Rev A: This revision replaces previous releases  
July 15, 2015 Revised per comments.

## BLIND GUIDE SUPPORT IMPROVEMENT Prevost vehicles

On the vehicles affected by this bulletin, change the lower blind guide supports for a new style with two anchor screws.

Figure 1

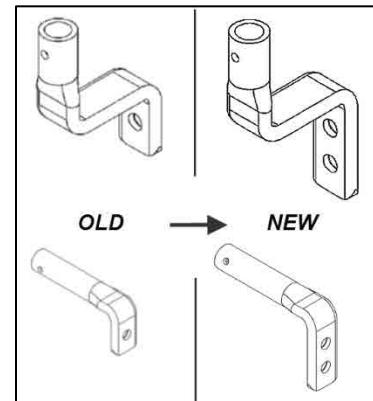
Replace the lower supports on the blind guides. Keep and re-use hardware.

Figure 2

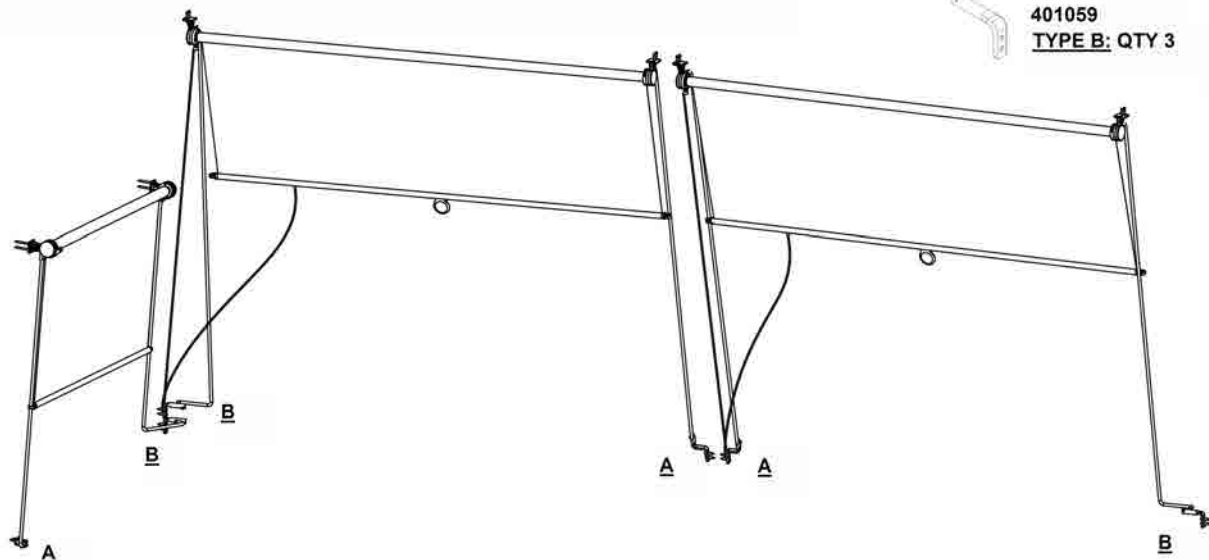
Fix the new support in the existing hole on the trim, using the upper hole on the support tab.

Drill a new 9/64" hole for the new screw using the lower hole on the support as a guide. (fig.2)

Secure support with a new screw #5001155 (fig.2).

Secure the new support to the guide with the reserved #4-40 screw. (fig.2)

FIX SUPPORT IN EXISTING HOLES BY UPPER HOLE ON SUPPORT TAB.  
DRILL 9/64" DIAMETER HOLES IN BUS TRIMS USING LOWER HOLE AS GUIDE.  
ADD SCREW 5001155 QTY 6. RE-USE 4-40 X 1/4" SCREW (5001091)
